Overview

The purpose of this notification is to communicate a mask change for all production Spartan®-6 FPGA devices and a speed file change for all Spartan-6 –3N speed devices.

Figure 1: Package Topmark

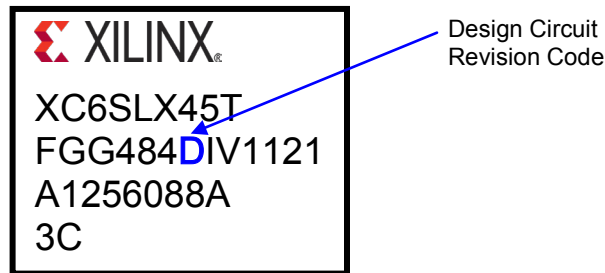
Affected devices are identified by the design circuit revision code as shown in the following package topmark.
